TECHNICAL BULLETIN

No: **DVD 200201R**
Product: **DVD**

Models: **SD 1700, SD 1750, SD 2700**

Subject: Parts Change Notice

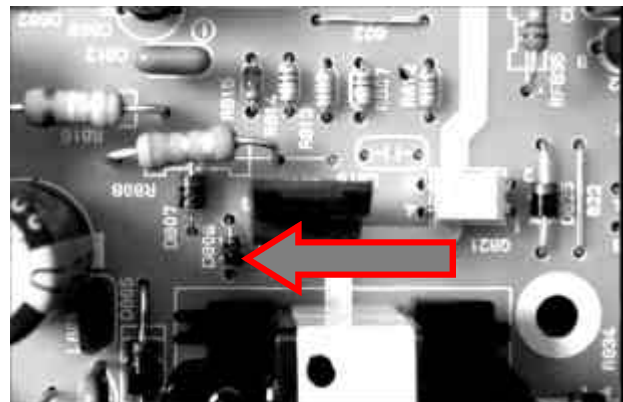
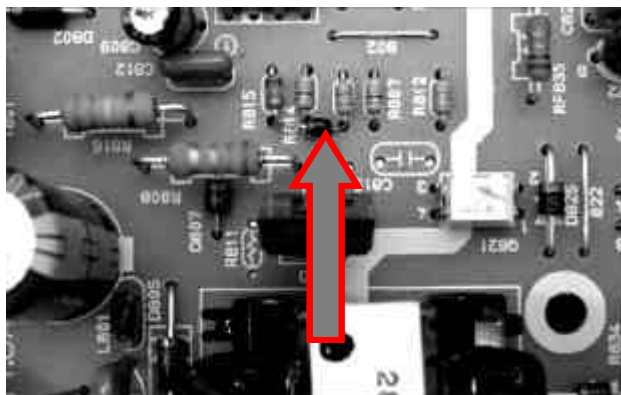
Symptom: DEAD –Defective Q801 (PN 79050088) and F801 (PN 79087008)

Corrective Action: Replace Q801 and F801 as indicated. Replace D808 30 volt Zener (PN- 79060088) with D808 6.8 volt Zener (PN-79060029). The diode will be located in either of two locations as noted in the diagrams. Replace the diode in the same location and orientation as removed. Add a 56k Ω , ¼ watt, +/- 2% carbon film resistor (generic part) between the gate and ground of Q801.
